Addendum No. 5

City of Coquitlam

RFP No. 25-002

Burke Mountain Athletic Park Construction Services

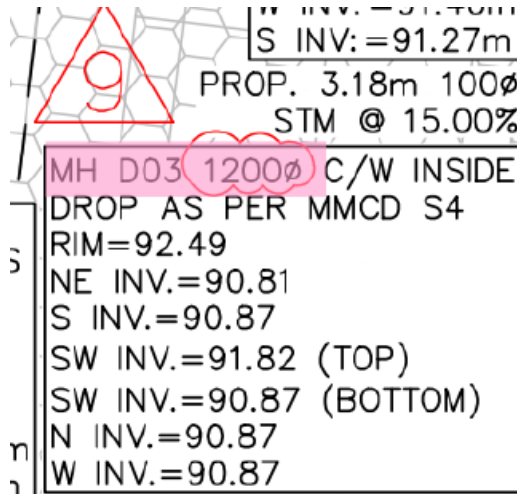
A1) CORRECTION

The following correction is issued by the Architect to revise their Drawings:

- **Architectural Addendum No. 5**

See Attachment No. 2 to this Addendum No. 5.

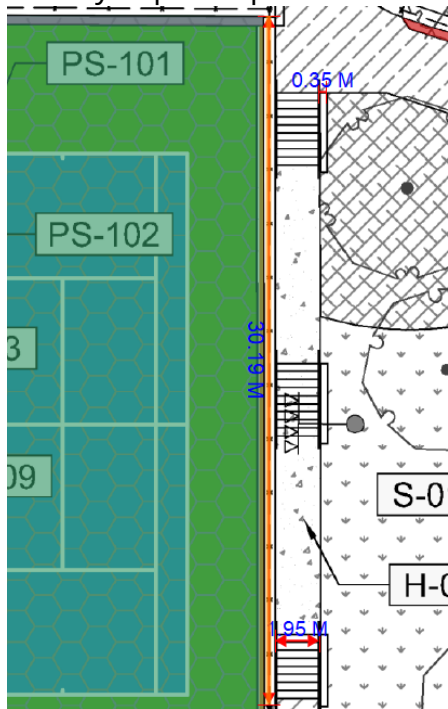
Q3. Could you please provide the detail for the cheek wall?

A3. See Architectural Addendum No. 4 landscape drawings. Detail 2, LD-02 has been updated to include the cheek wall detail. Note the handrail is not to be attached to the cheek wall.

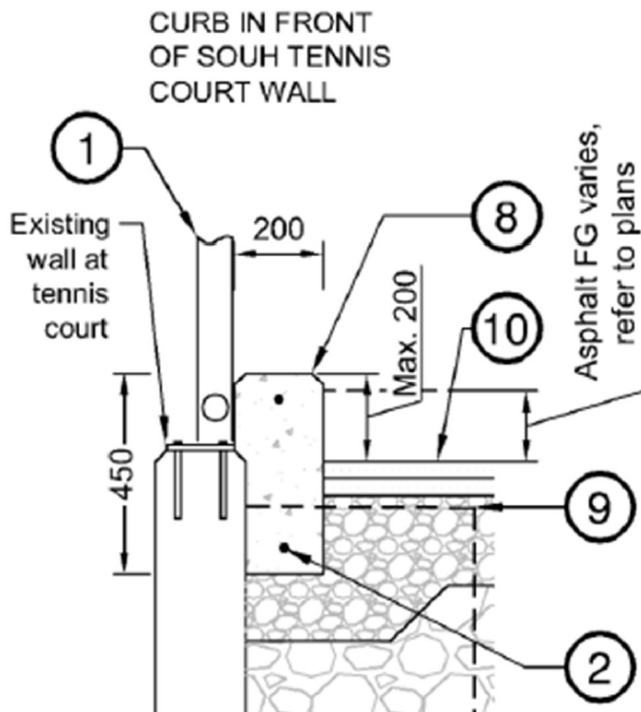
Q4. What is the purpose of this curb - see Item 8? For ball retainment? If that is the case, shall we need it on west side of the tennis court as well where the existing wall top are at current ground level?

- A4. This curb is to support the asphalt which is crowned in the north/south direction in the middle of the tennis court. The existing wall top matches the lowest elevation of the asphalt surface and does not accommodate the crown. This curb is only required on the south side of the court as shown.**

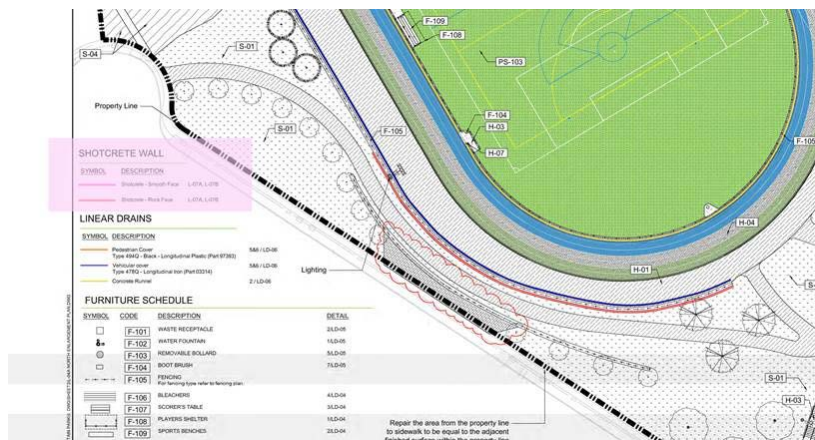
Q19. Finally, the top and bottom rails for the 3M fence are specified at 60 mm, but there's no mention of the mid-rails. Should we assume they are also 60 mm?

A19. All cross bars on 3M high fence are 60mm O.D.

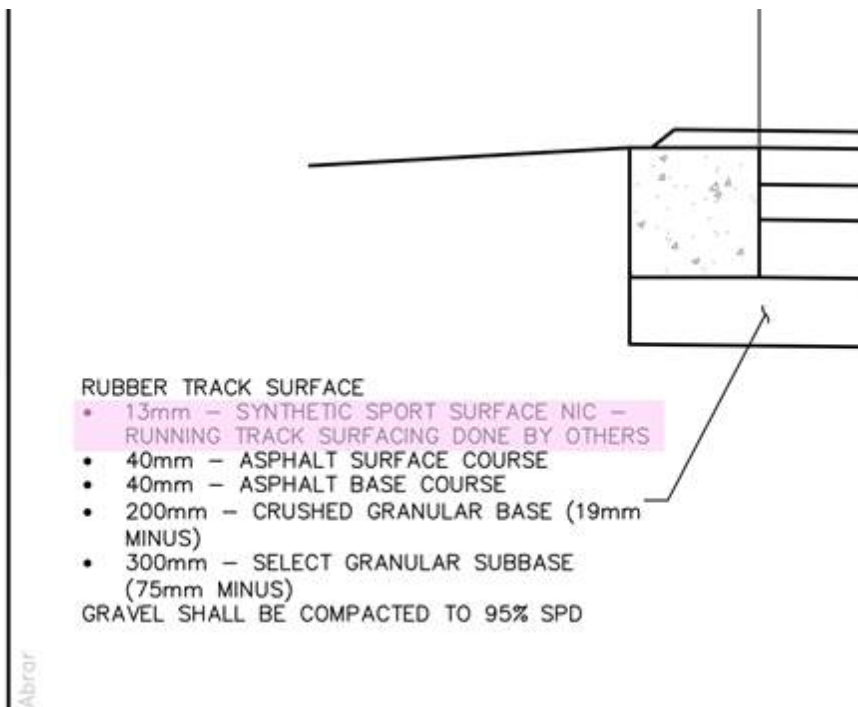
Q22. Pay Item X mentions a rubber surface track, but it's unclear whether this scope is included or provided by others. The detail note indicates "by others". Could you please confirm whether the rubber track surface is part of our scope?

A22. Rubber track is part of the Scope of Work.

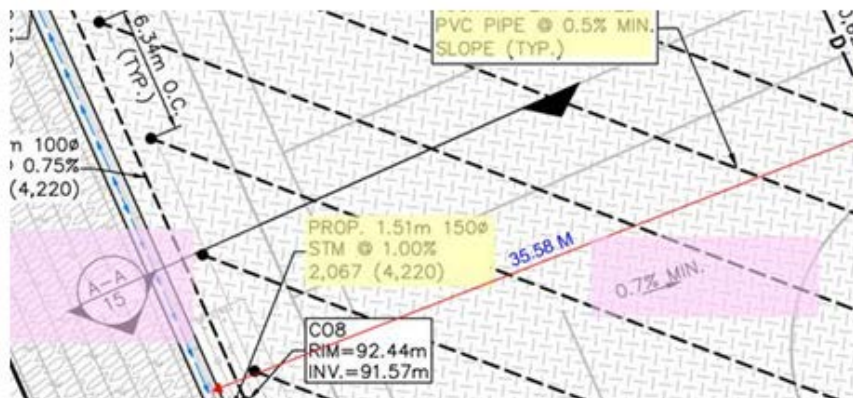
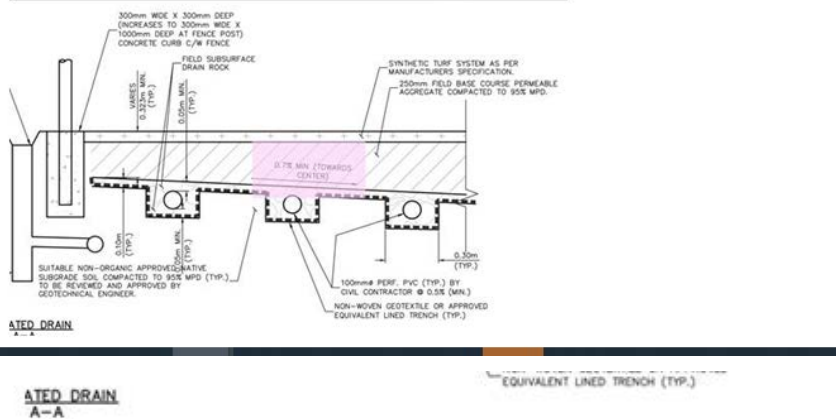
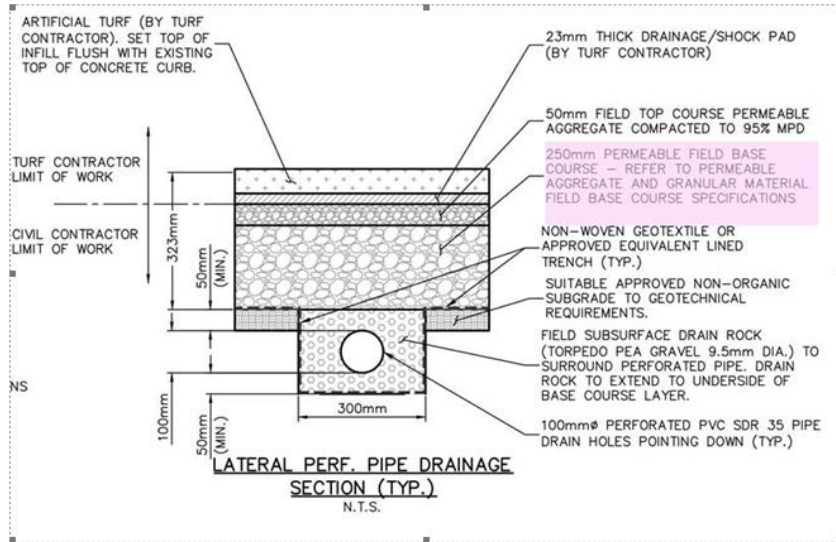
Q23. On Sheet 15 of 26, two details conflict—one shows a 250 mm base course, while another shows a sloping subgrade with a thicker base course at the centre. Which detail is correct?

A23. Refer to updated civil drawings from Aplin Martin where this conflict has been resolved issued as part of Architectural Addendum #01.

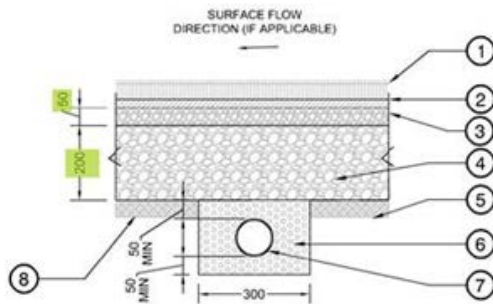
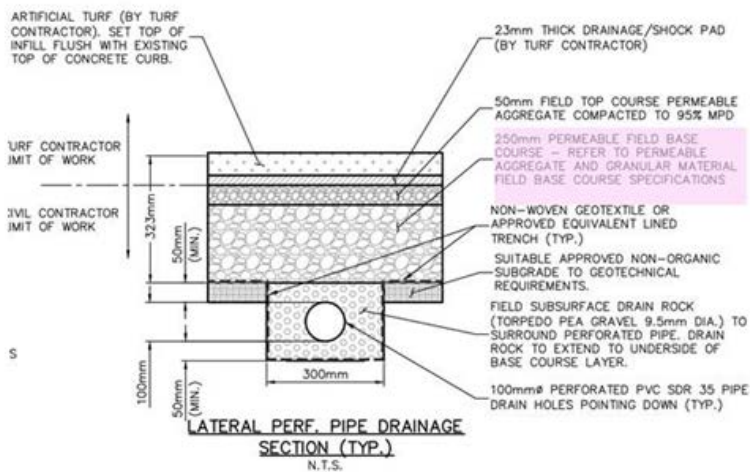
Q24. Drawing 16 of the Aplin Martin set shows a base course of 250 mm minimum, plus additional depth to account for the slope to centre. However, VDZ drawing LD-06 shows a 200 mm base course. Which one should we follow?

A24. Refer to the update civil drawings issued as part of Architectural Addendum #01 from Aplin Martin where this conflict has been resolved. Specifications note 250mm of clear field base gravels: 50mm field top course permeable aggregate, and 200mm field base course permeable aggregate. This is a minimum standard that may need to be exceeded meet grading requirements. Where this depth

needs to be exceeded, the field base course permeable aggregate may be increased from 200mm thickness as required.

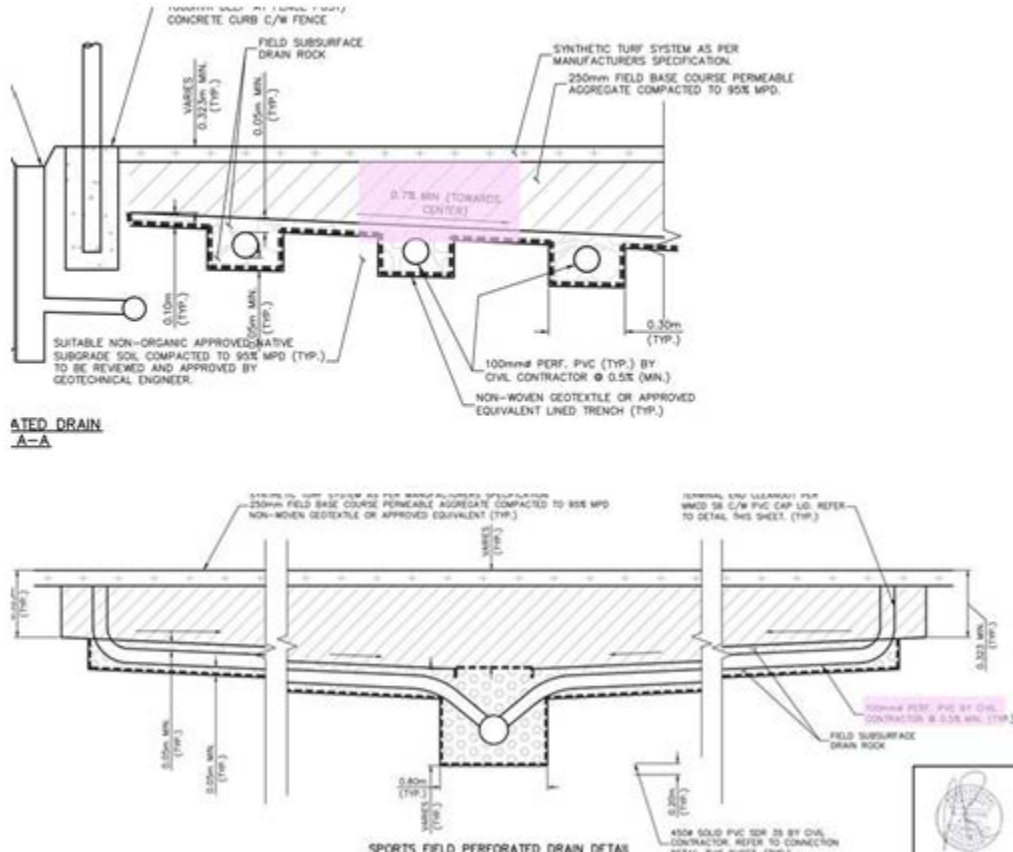
Q25. On drawing 15 of 26, two different slopes to the centre are shown for the subgrade under the field--- one detail shows 0.7% and the other 0.5%. Which one is correct?

A25. 0.7% refers to the minimum subgrade slope towards the centre of the field while 0.5% refers to the minimum slope of the perforated drainage pipe under the field. The Contractor is to ensure these minimum slopes along with any minimum cover requirements specified in our drawings are met, and that the perforated drainage pipe does not protrude into the subgrade.

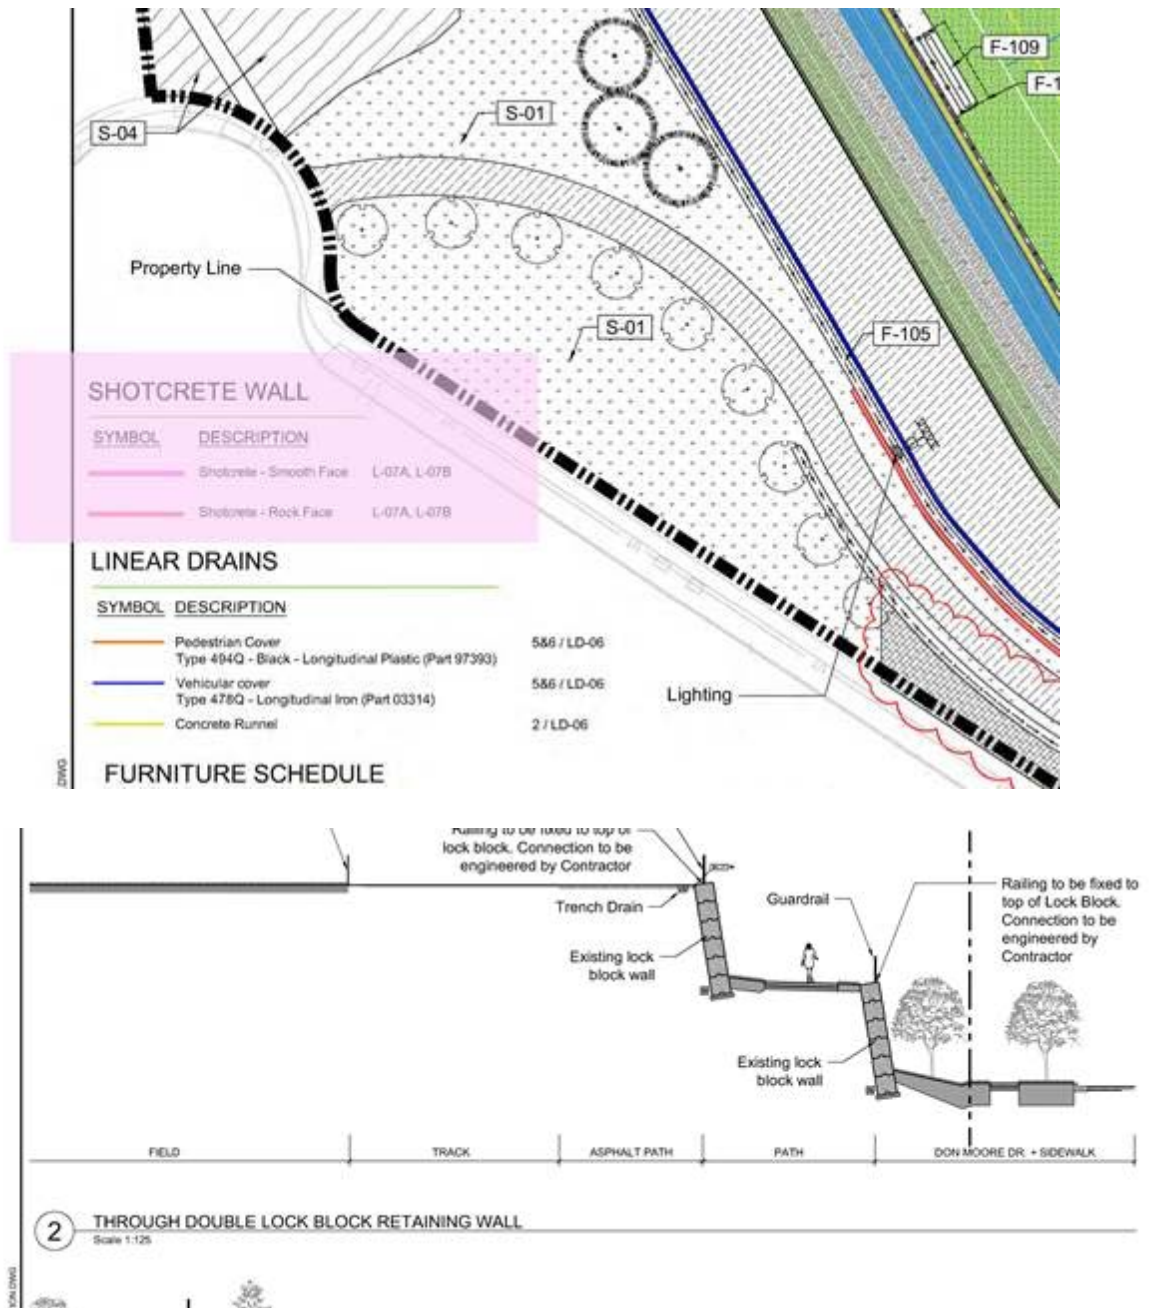
Q26. Q30 On Plan L-04B, a shotcrete wall is shown in this location. However, Section 2 on LS-03 below indicates a lock block wall instead. Could you please clarify which one is correct?

A26. See updated landscape Section 2, LS-03 showing shotcrete facing as an alternate price. Elevation 2, L-07B also updated to note alternative pricing for shotcrete.

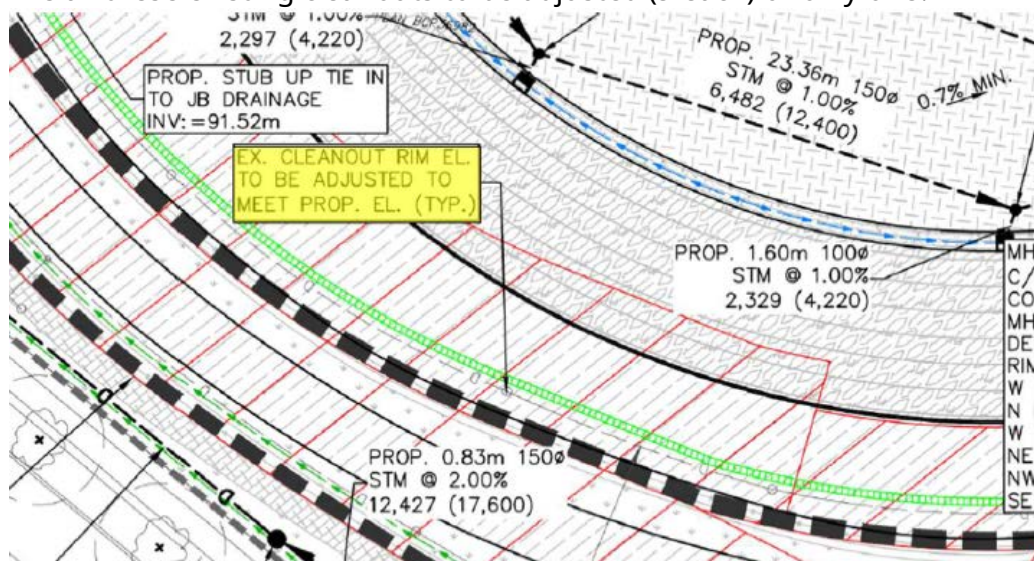
Q29. Are all these existing cleanouts to be adjusted (9 each) or only one?

A29. The highlighted callout is typical for all existing cleanouts. All existing cleanouts are to be adjusted to meet proposed surface elevation.

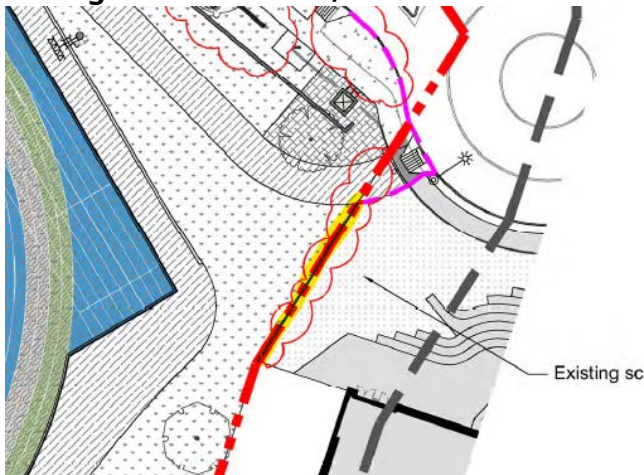
Q39. Thurber Engineering Drawing 2774-00-S-503 indicated shotcrete finish reference page L-05B. No page exists, are we to assume page L-07B?

A39. Shotcrete finish notes see Architectural Addendum #05 on page L-07A.

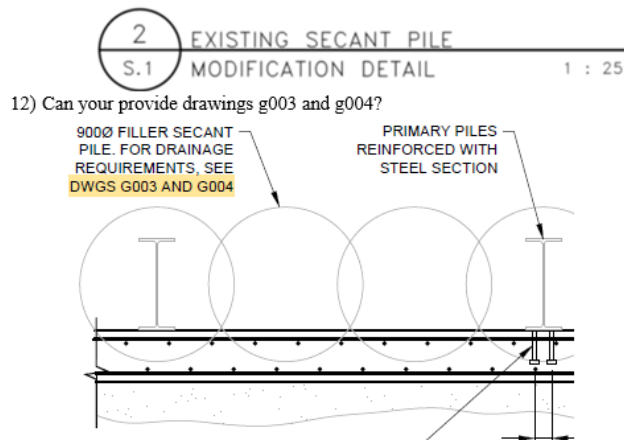
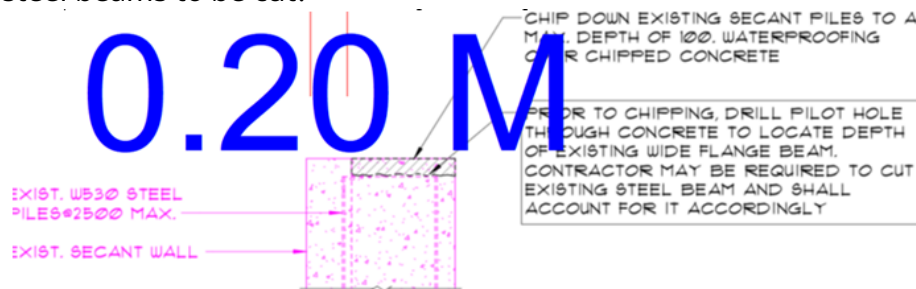
Q44. Thurber drawings show nelson studs, has this been completed already by the previous contractor? Or is this to be included in this tender? Can you please provide an elevation of the layout and confirm if they are to be installed on all piles?

A44. No, Nelson studs have been installed on the parks site. The installation of the Nelson studs are part of the RFP. Nelson studs are to be installed on every steel beam as stated on the drawings. Details of Nelson studs are available, labelled on the detail and on Note 1 on that drawing.

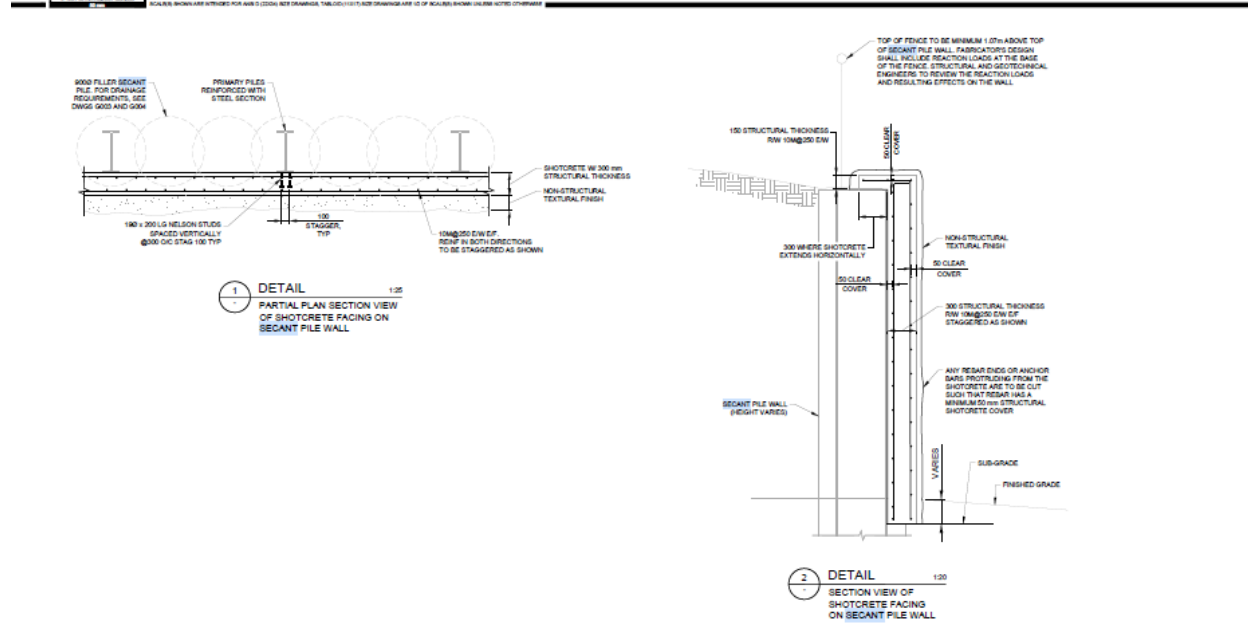
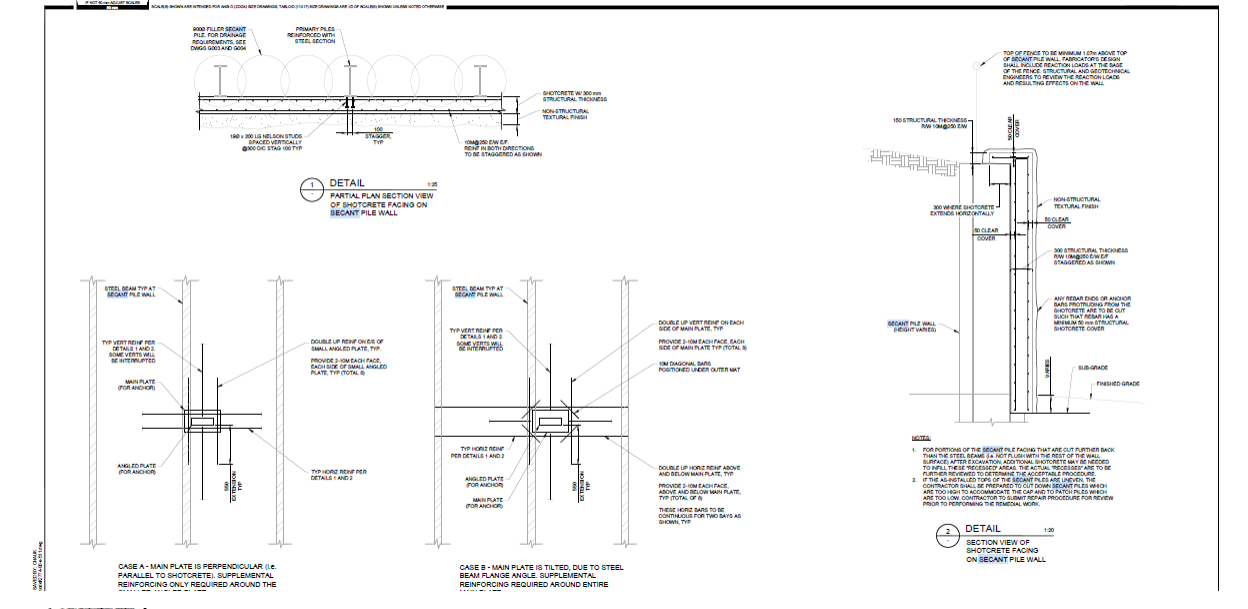
Q47. There are two secant wall details in the project manual. One shows the anchor rebar, the other does not. We want to make sure everyone knows about the rebar at the anchors.

A47. The structural drawings pertaining to the shotcrete show anchors and rebar at select locations.

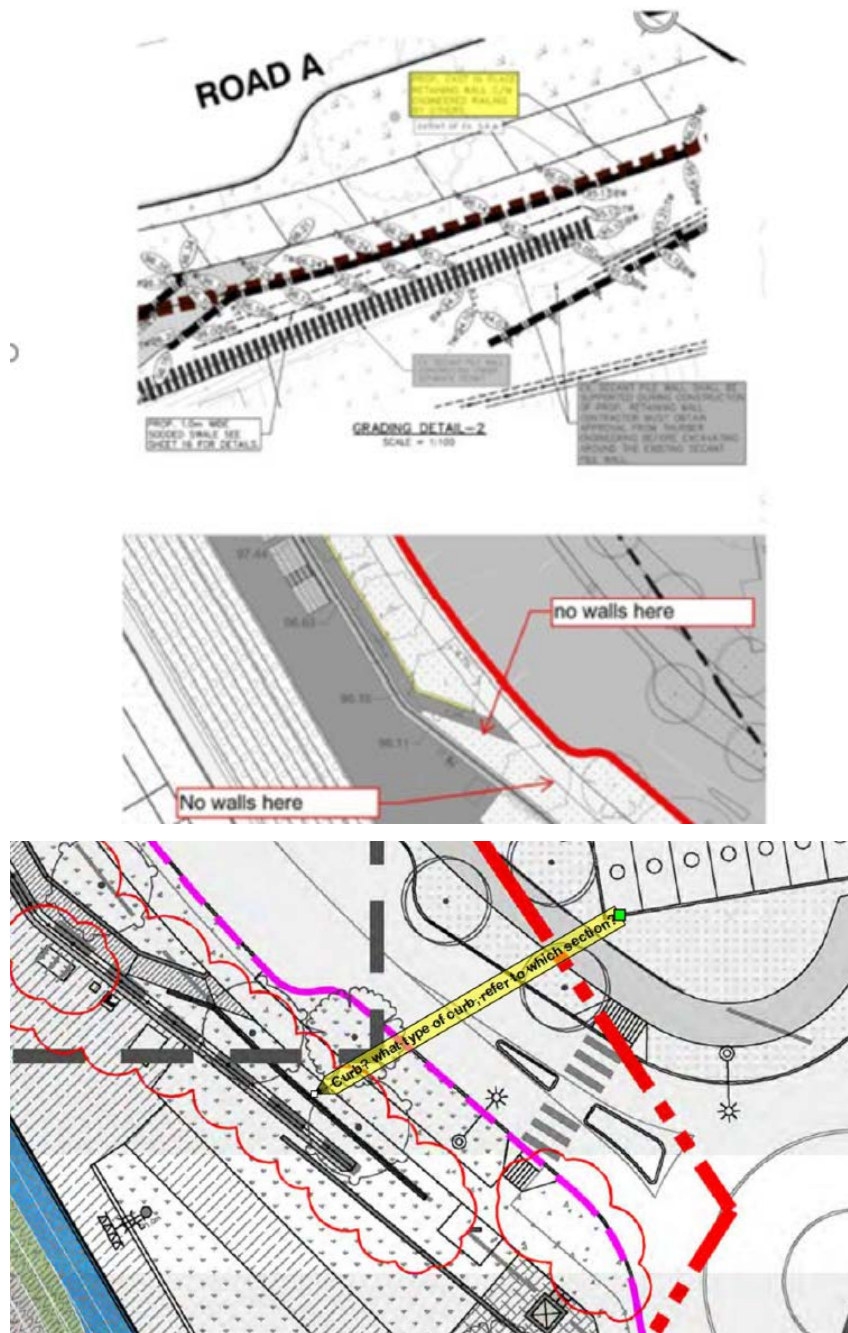
Q48. There is No wall at this area on Architectural drawing, but there are on Landscape and grading detail, in grading detail indicates Cast in place retaining wall

A48. See A1 above showing this retaining wall to match civil & landscape.
